**MEETING PACKET FOR
THE REGULAR MEETING OF
MONDAY, MARCH 9, 2026
7:00 P.M.**

**2036th Regular Meeting Agenda of the Council of the City of Livonia
Monday, March 9, 2026**

1. [WAIVER PETITION: Petition 2024-02-02-03, submitted by Stonefield Engineering & Design on behalf of Haggerty Six Partners, LLC, seeking approval of all plans in connection with Buildings F and I, pursuant to Council Resolution #135-24, which previously approved a waiver use at the Shoppes at College Park as part of a Planned General Development, located on the north side of Six Mile Road between Haggerty Road and Fox Drive in the Southwest ¼ of Section 7. \(Approving\)](#)

WAIVER PETITION: Petition 2024-02-02-03, submitted by Stonefield Engineering & Design on behalf of Haggerty Six Partners, LLC, seeking approval of all plans in connection with Buildings F and I, pursuant to Council Resolution #135-24, which previously approved a waiver use at the Shoppes at College Park as part of a Planned General Development, located on the north side of Six Mile Road between Haggerty Road and Fox Drive in the Southwest $\frac{1}{4}$ of Section 7.

SITE PLAN

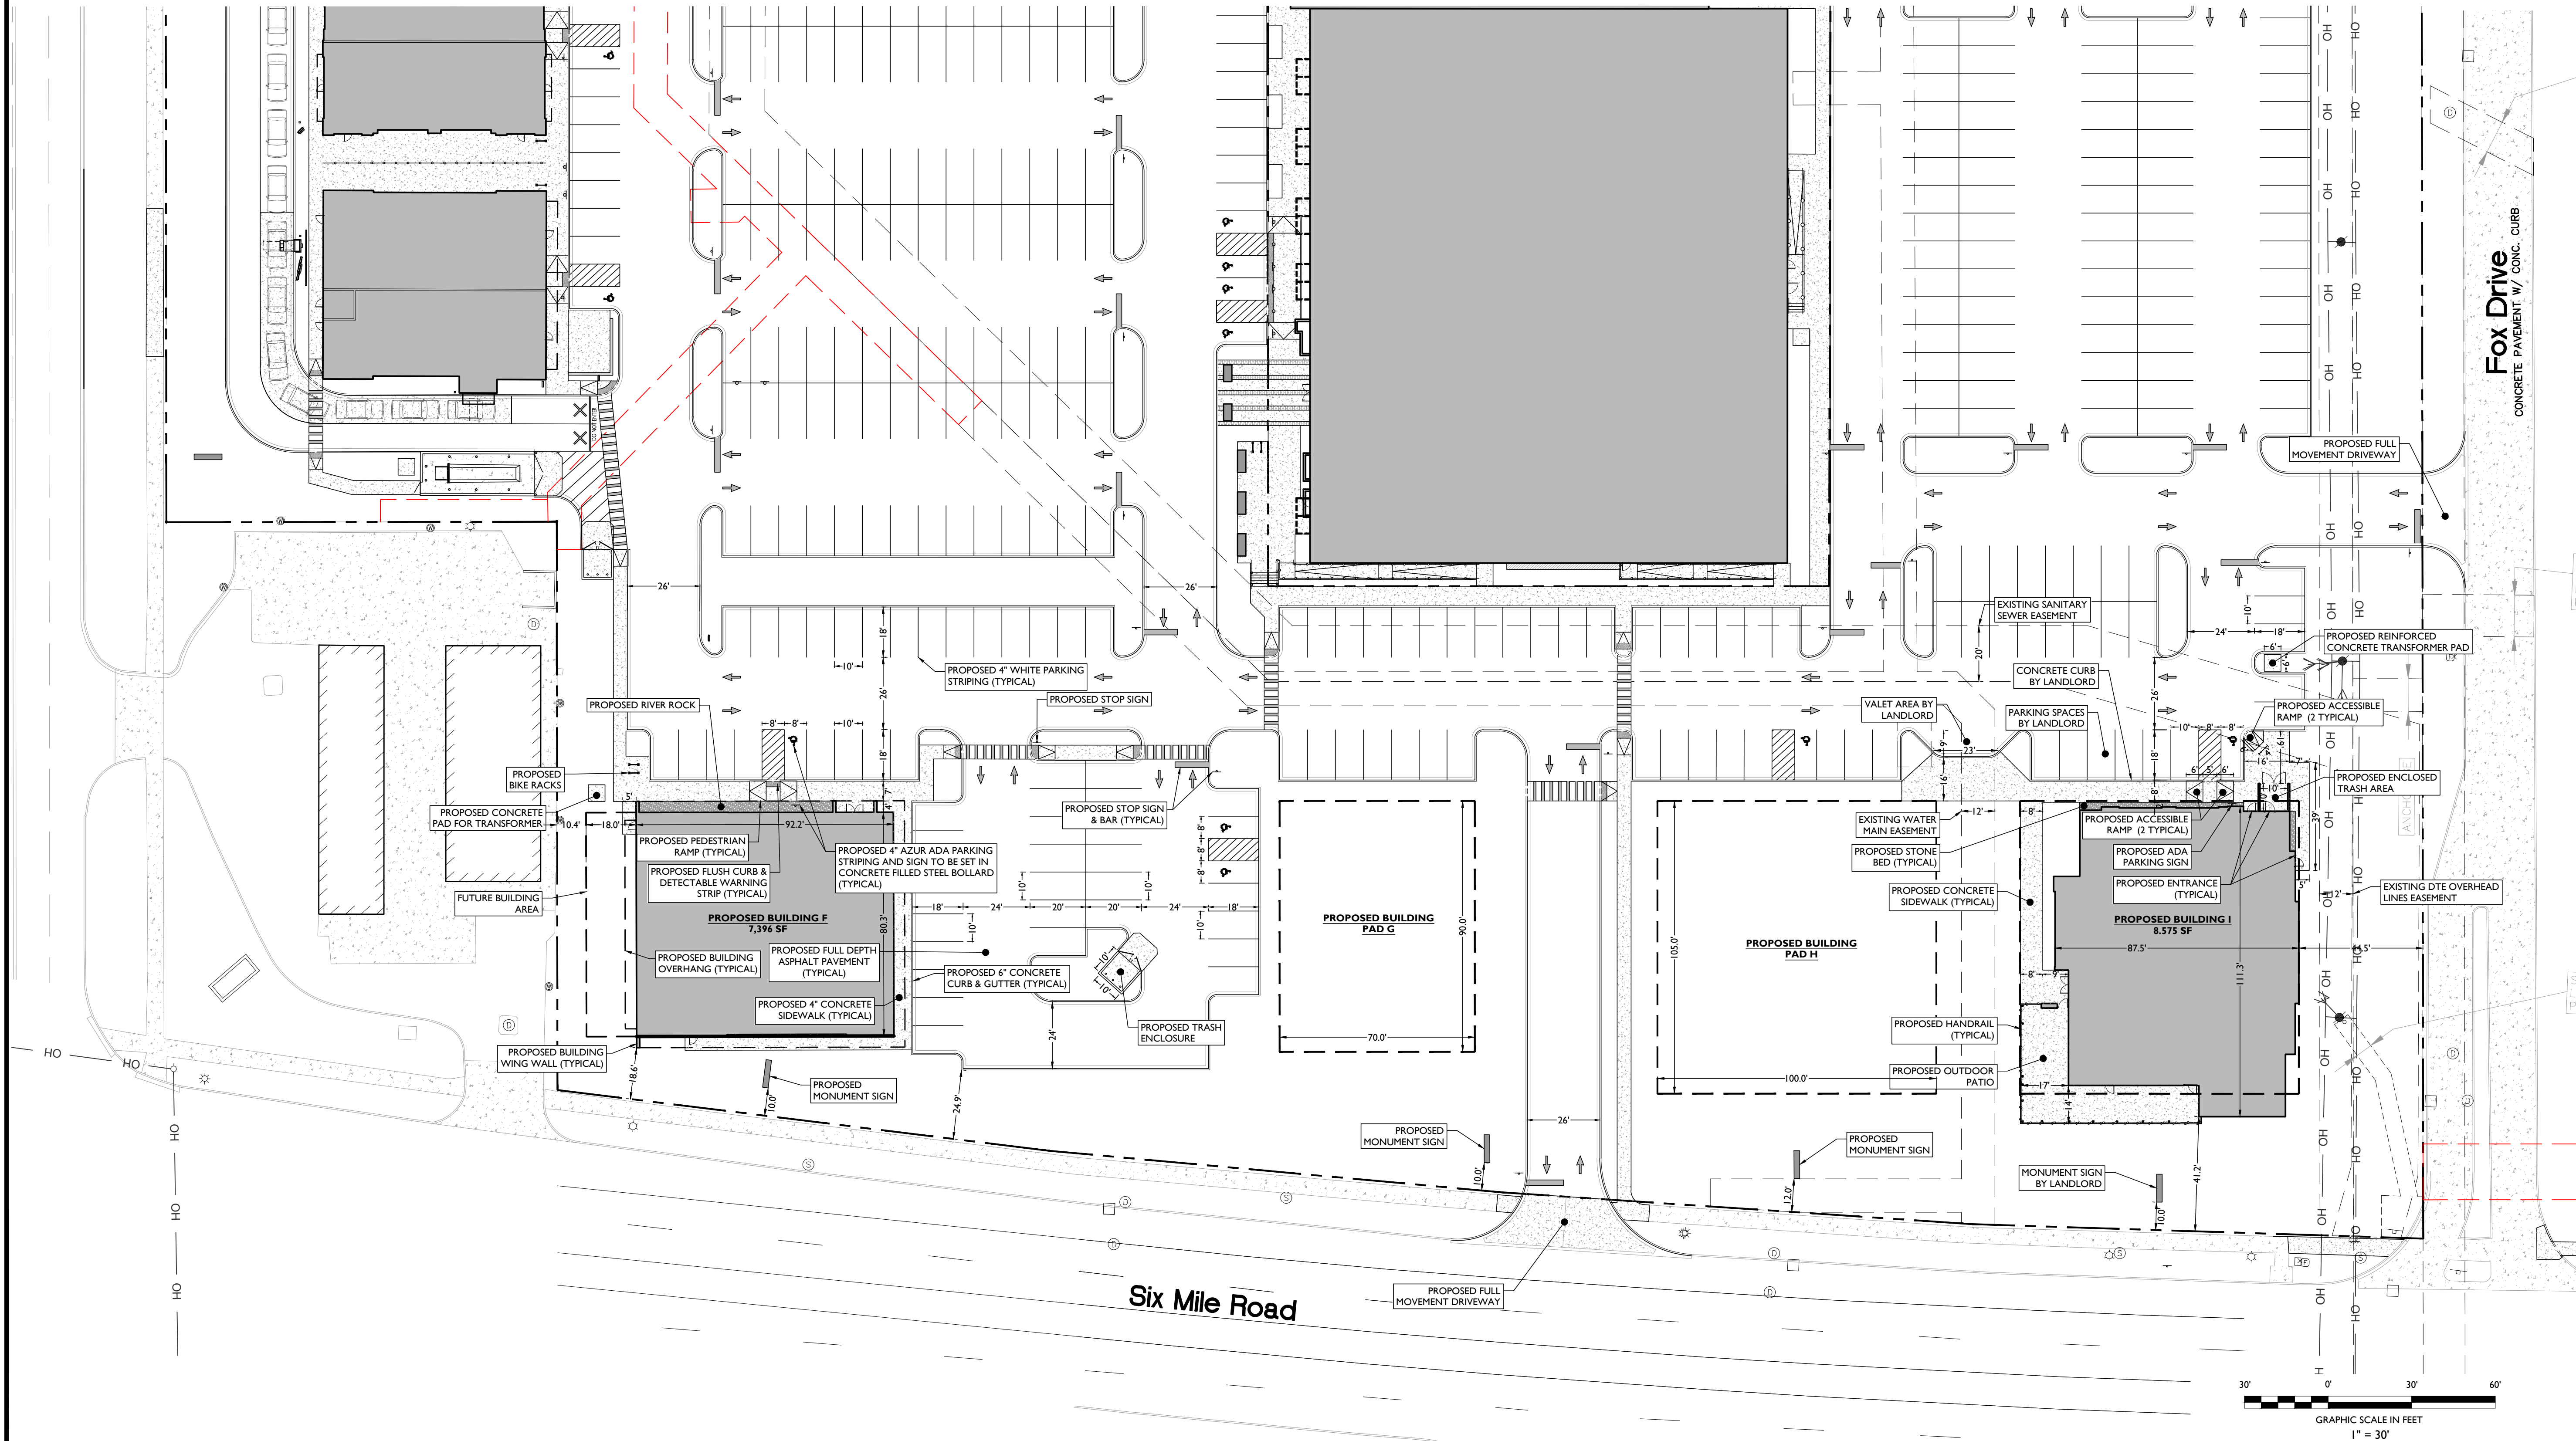
1. The Site Plan marked by Sheet C-3 dated January 5, 2026, as revised, prepared by Stonefield Engineering & Design, are hereby approved, and shall be adhered to;
2. The Landscaping Plan marked by Sheet C-5 dated January 5, 2026, as revised, prepared by Stonefield Engineering & Design, are hereby approved, and shall be adhered to, except that

C-5

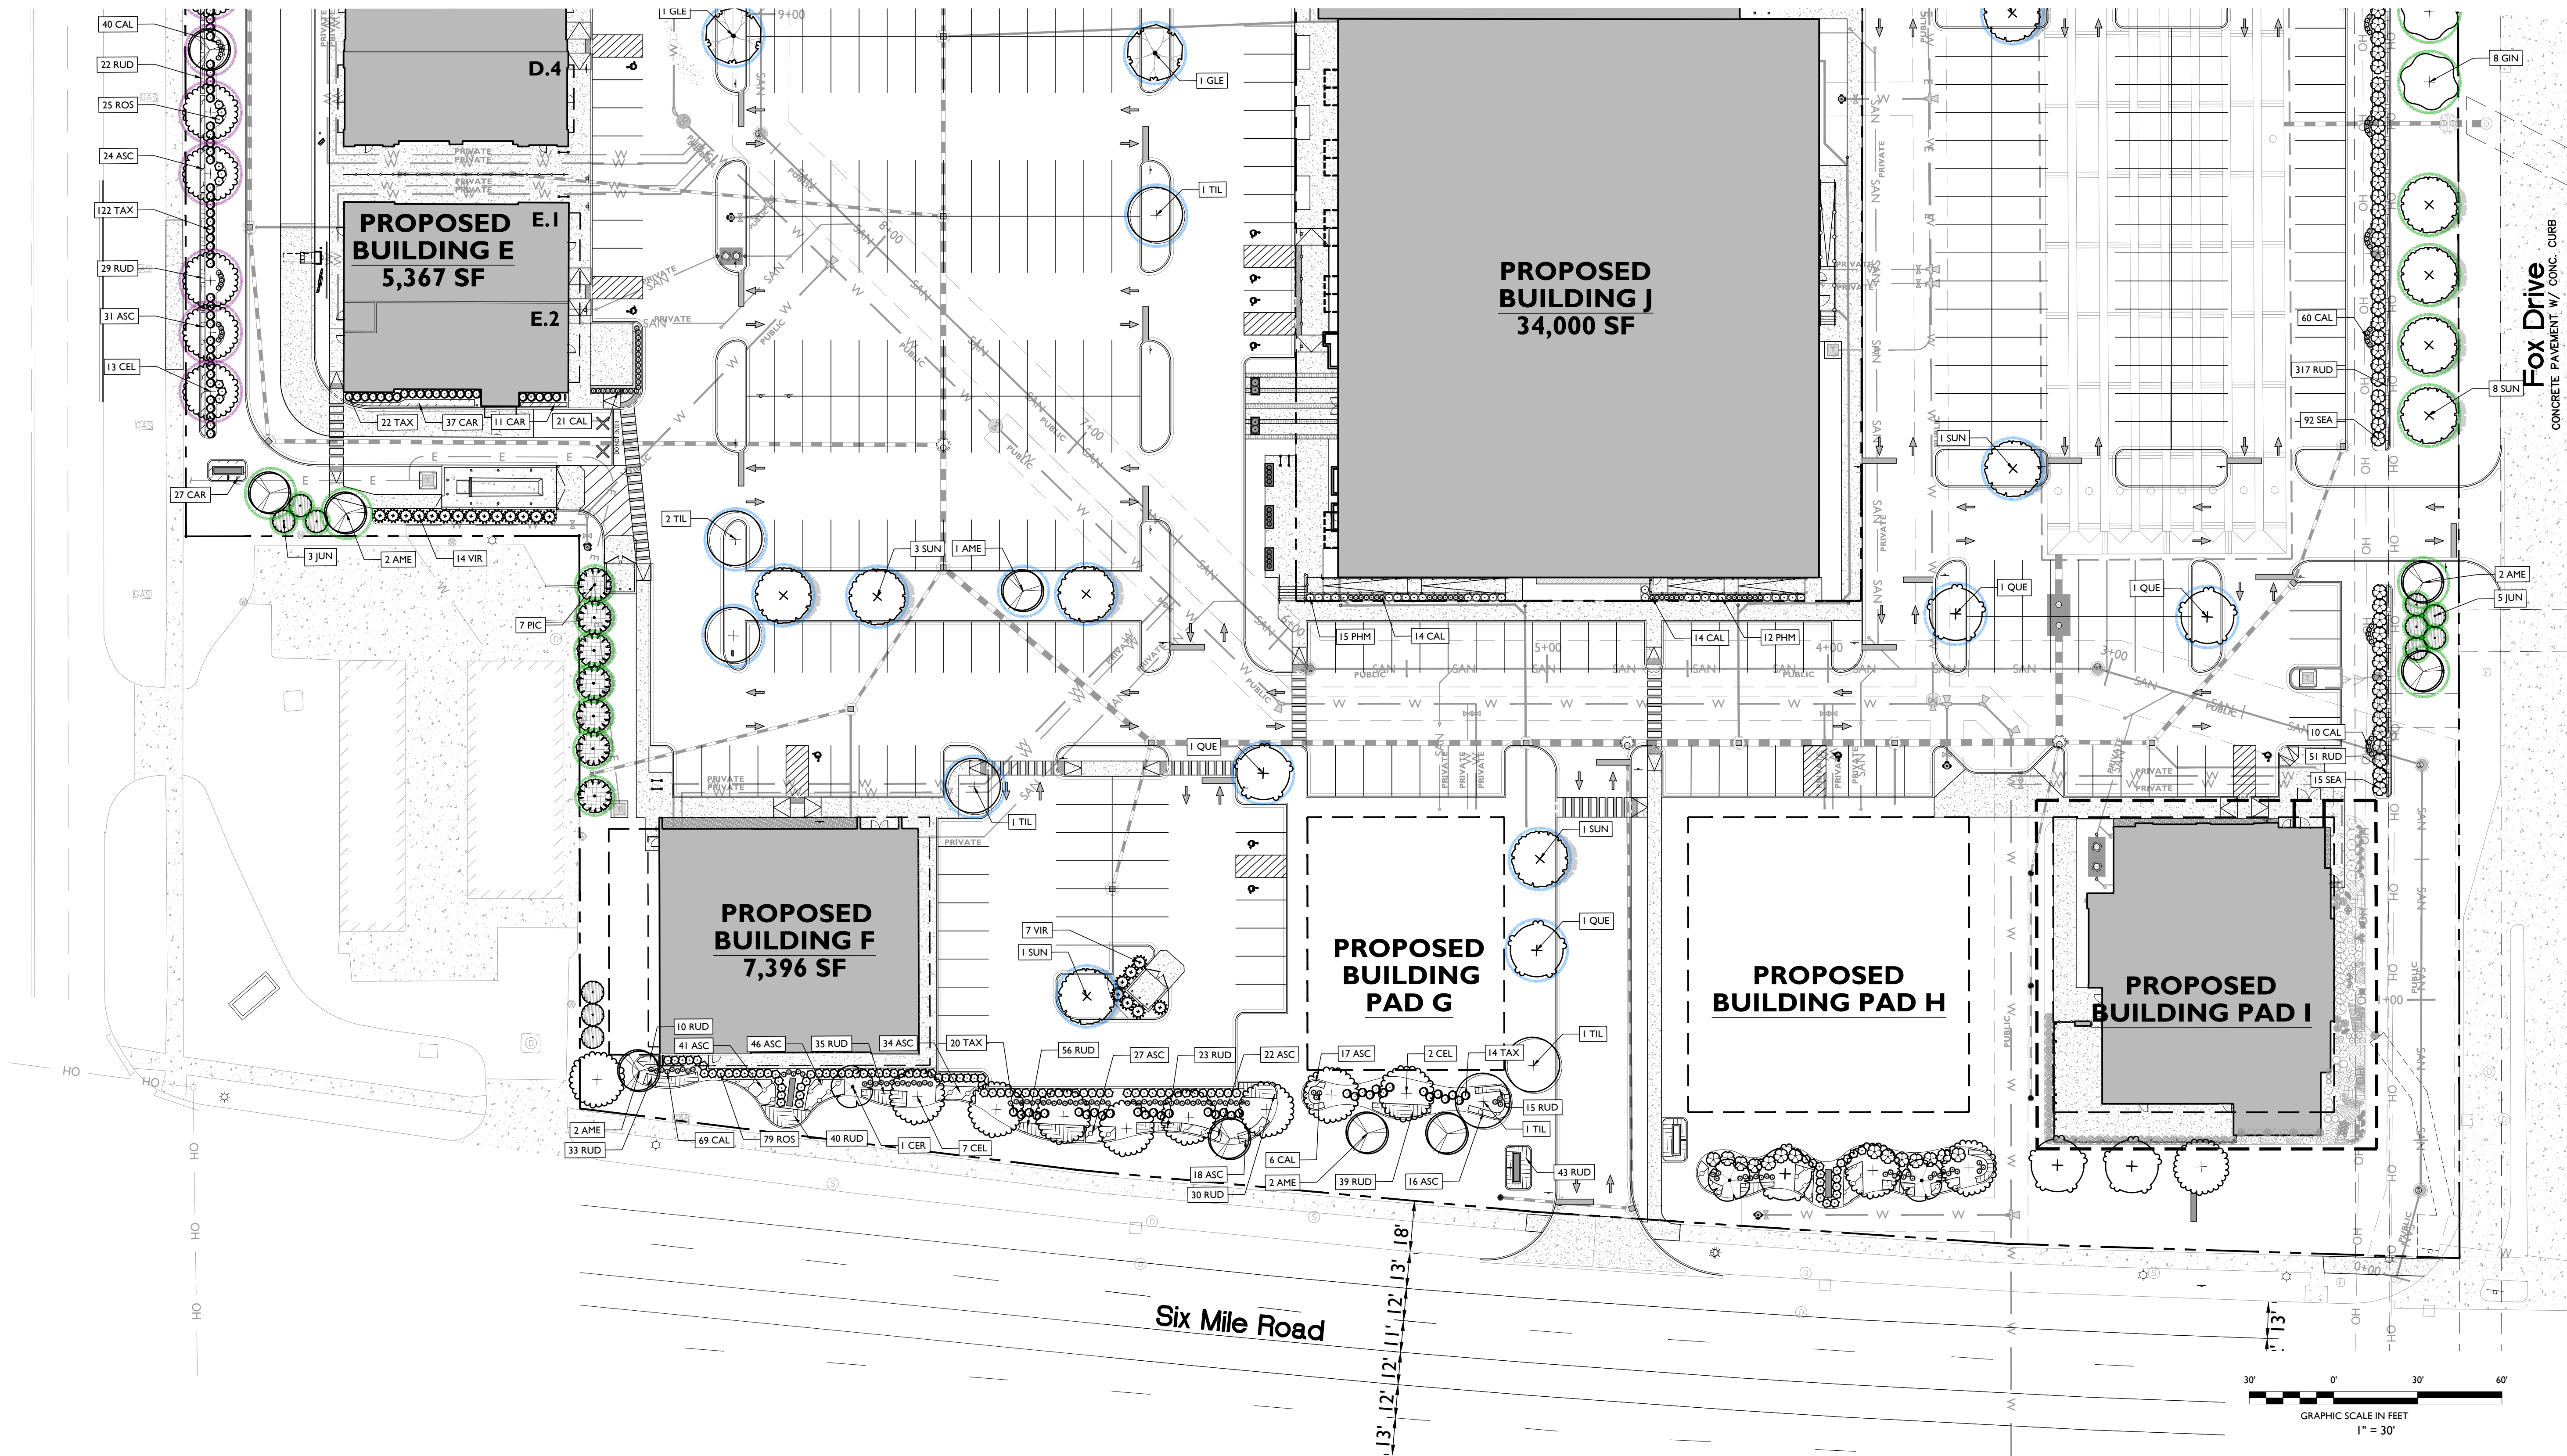
landscaping along 6 Mile Road in front of Building “I” reflect the landscape design of the rest of the Six Mile frontage to the satisfaction of the Planning Director;

SHEET + TITLE
EXTERIOR
ELEVATIONS

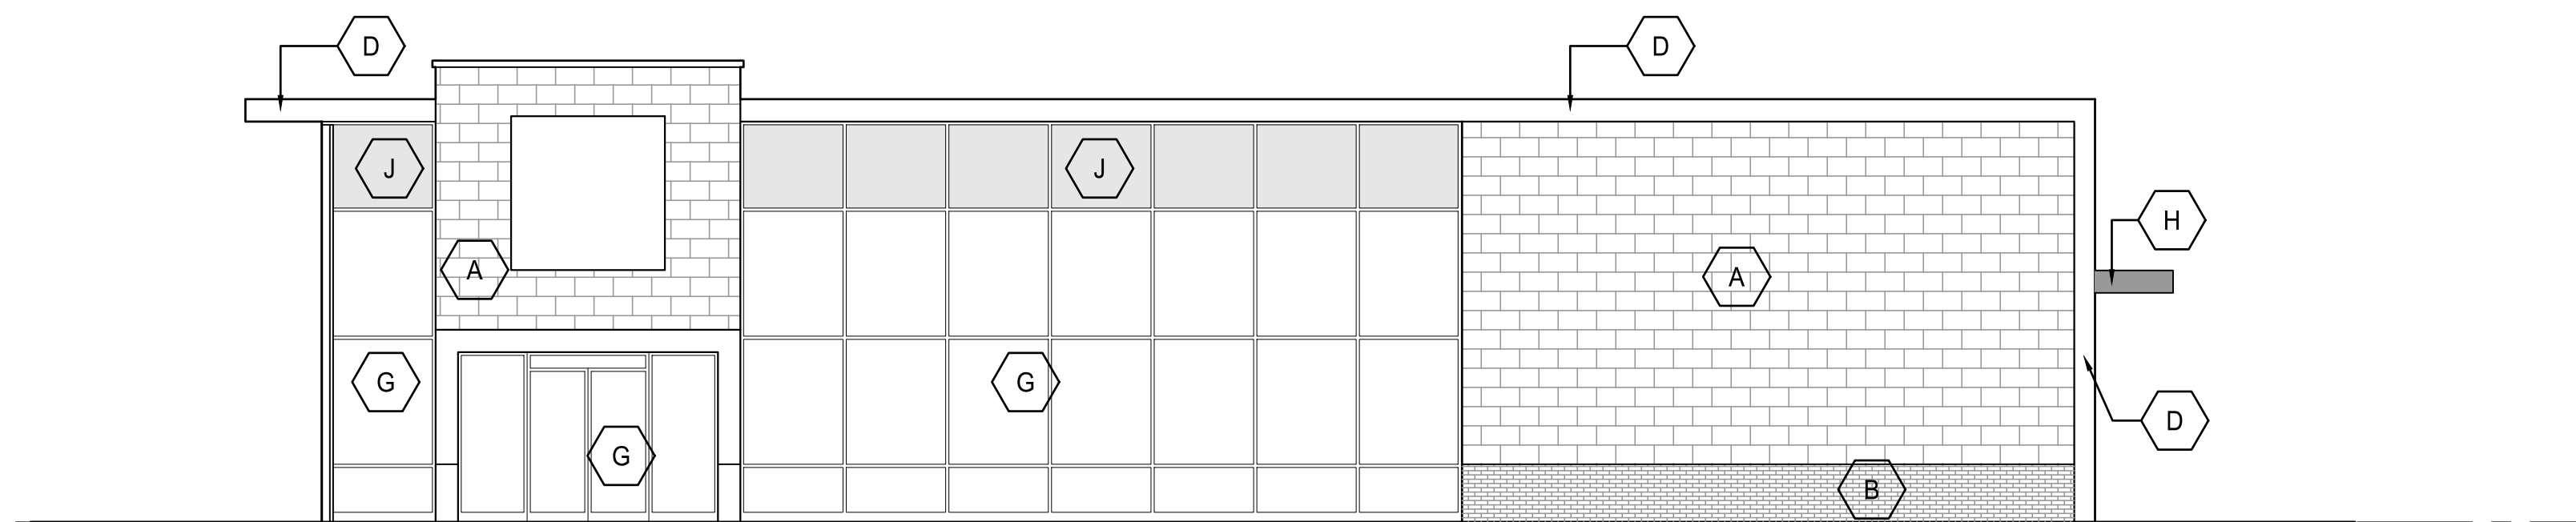
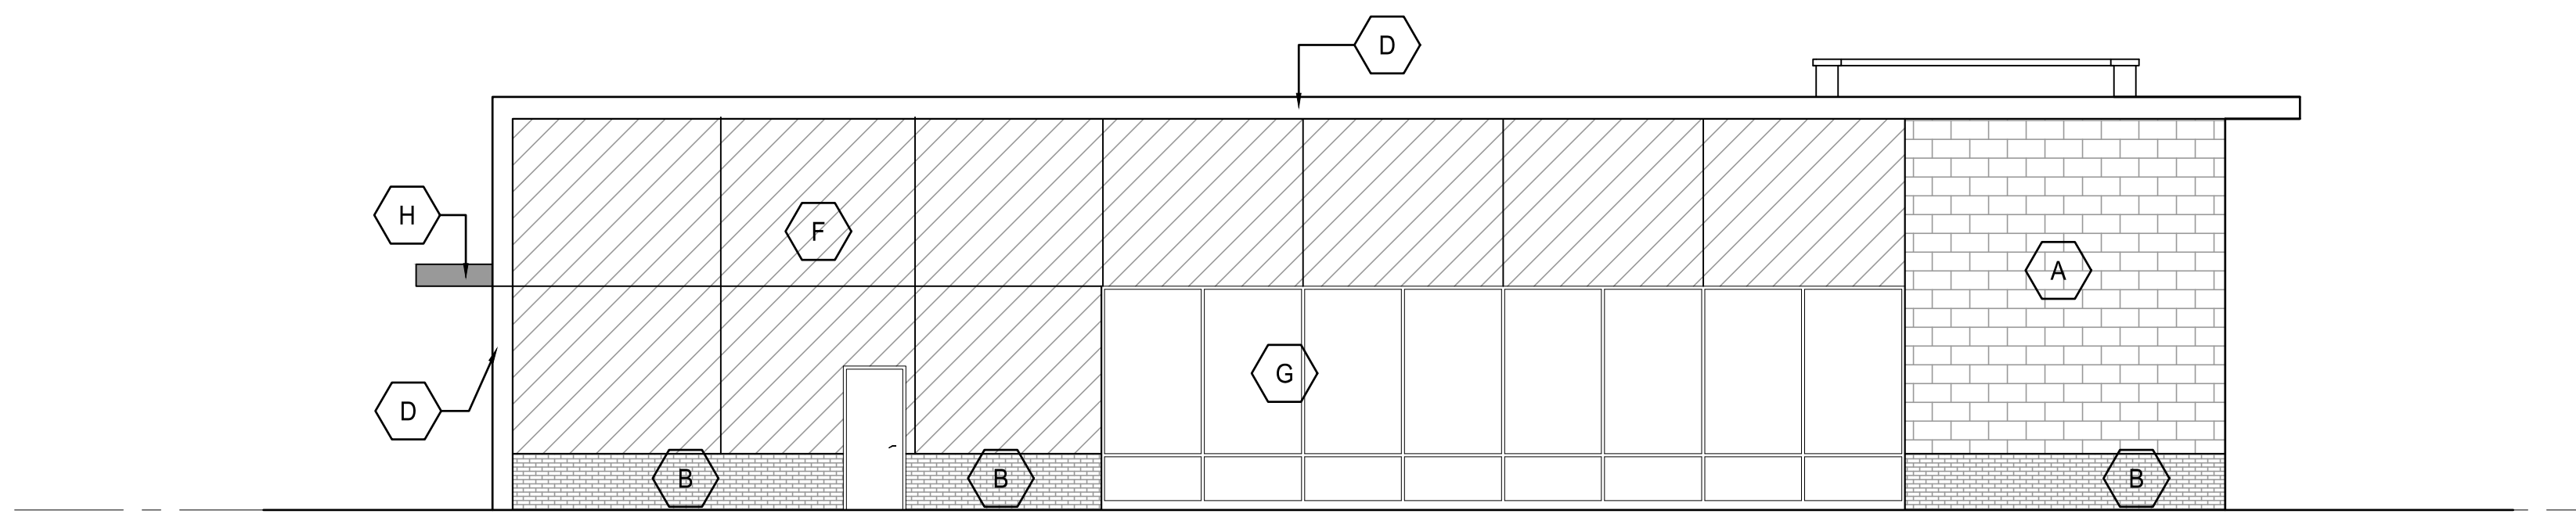
Thanks, Kevin. We'll get this scheduled. In the meantime, please fix an error found on Sheet A-300, which is the file BLDG F Elevations. It erroneously refers to Retail Building E.
